SUBJECT: EPA Comments on "Assessment of Dam Safety of Coal Combustion Surface Impoundments: GenOn Energy – Shawville Generating Station, Shawville, PA"

DATE: September 9, 2013

**Subject: Bottom Ash Pond Assessment Report
Shawville Power Station
Shawville, Pennsylvania**

Figure 2 – Cross Section 13-13 of the Northwest Berm of Ash Pond A

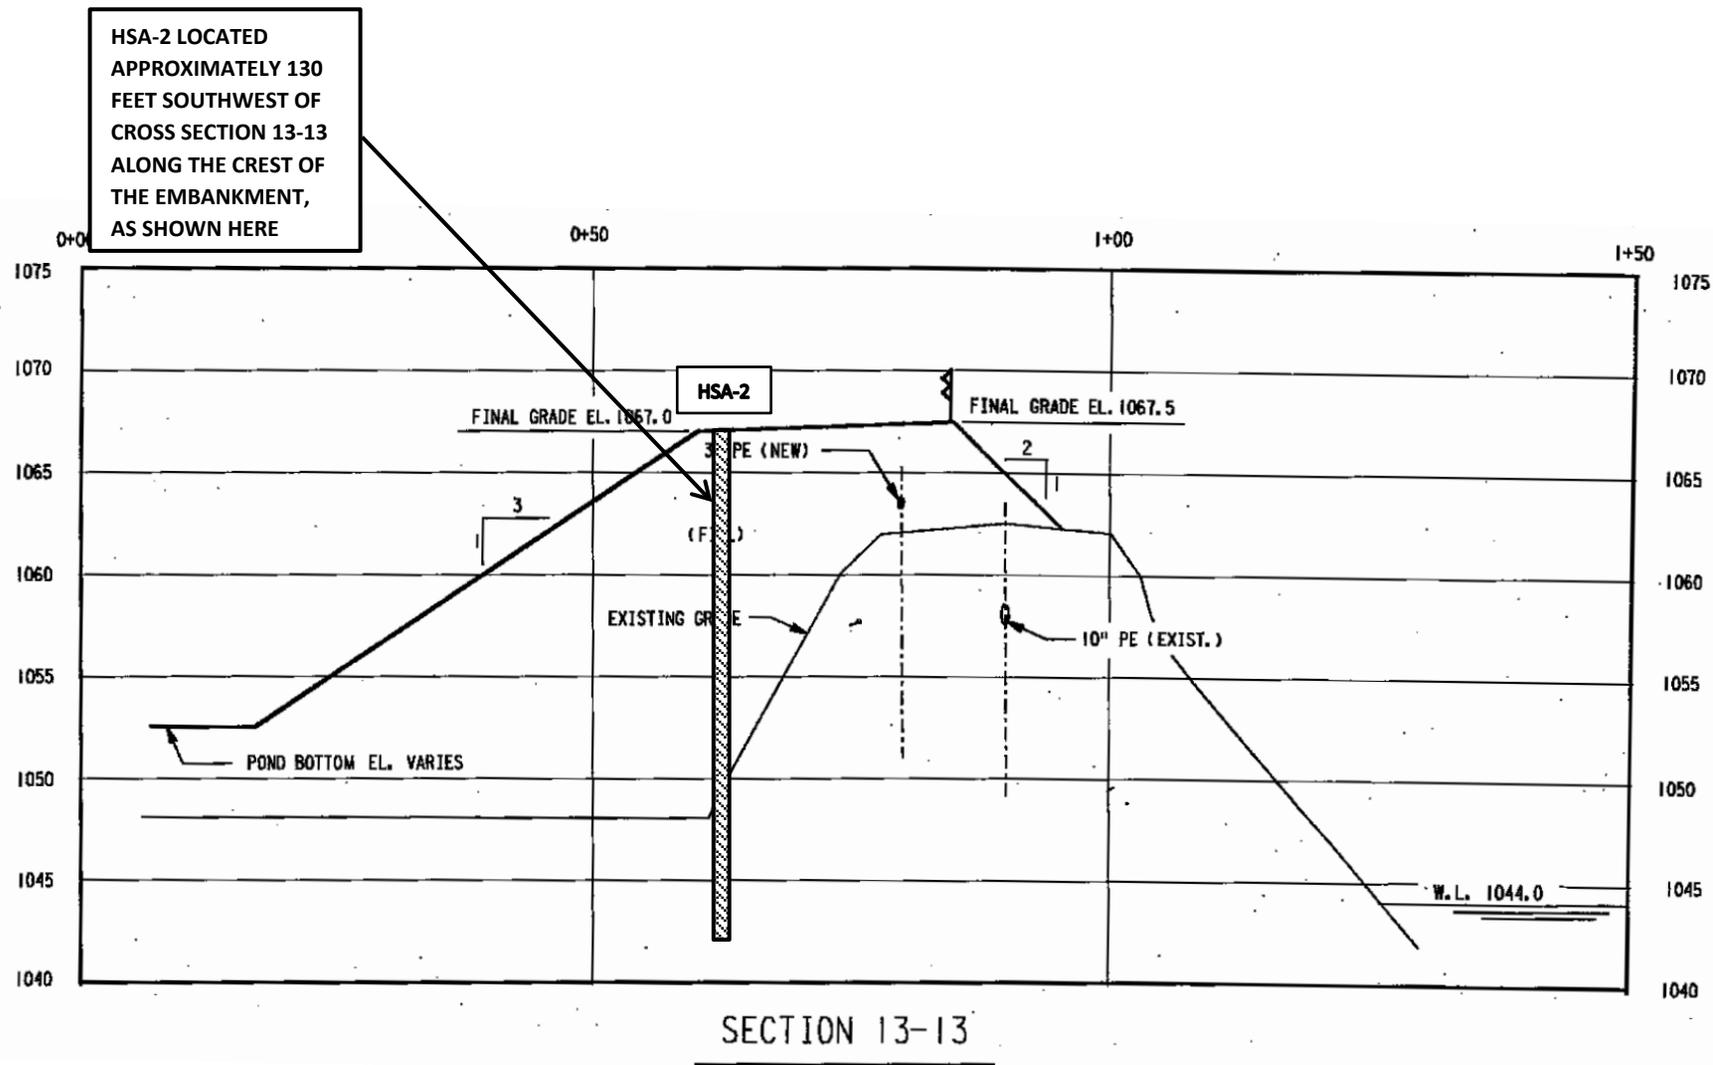
Does the configuration of the embankment, specifically as seen in elevation views from Figure 3 in the attachments of the report, present a concern in a flood condition in the West Branch of the Susquehanna River, i.e., elevated phreatic surface and potential subsequent downstream rapid drawdown condition in the downstream(outboard) slope? Additionally, would it be overly-conservative to analyze the downstream embankment based on its configuration and subsequent lack of lateral soil pressure buffering the embankment?

Given the close proximity to the West Branch of the Susquehanna River and the lack of any setbacks, benches, etc. on the slope, a recommendation to perform geotechnical slope stability analyses of these slopes would not be perceived as overly conservative in our opinion; however, we considered the following during preparation of our report recommendations:

1. The current impoundments or prior impoundment have been in operation at this site for over 60 years with no history of slope distress, failure, or other related incident.

2. The groundwater level in the embankment between the impoundment and the embankment is basically at river level. The West Br. Susquehanna River is not likely to remain at flood stage long enough to saturate the embankment to the point of elevating the phreatic surface substantially, especially considering that the soils between the river and the impoundment are not currently saturated due to the geomembrane liner on the floor and slopes of the impoundment.

3. Even if the slope did become partially saturated during flood stage, it is unlikely that the river level would recede more quickly than the soils forming the slope could drain, which is the condition that would be necessary to create the rapid drawdown instability you mentioned.

4. If the slope was prone to instability due to post-flood river recession, it is our opinion that there would be some history of slope sloughing, or other outward signs of slope distress. No signs of such distress or of past repairs or stabilization efforts was observed in the site visit.

If this impoundment were to remain in operation for an extended period of time, we would likely recommend a geotechnical study and slope stability evaluation. However, given it's long history with no incident and upcoming closure in the near future, we believe a regular visual monitoring plan looking for signs of slope distress is the most practical recommendation for Ponds A and B.

We concur with O'Brien and Gere's rationale for not requiring stability analysis of the embankments at the GenOn/NRG Shawville Plant based on the reasons enumerated in your email.
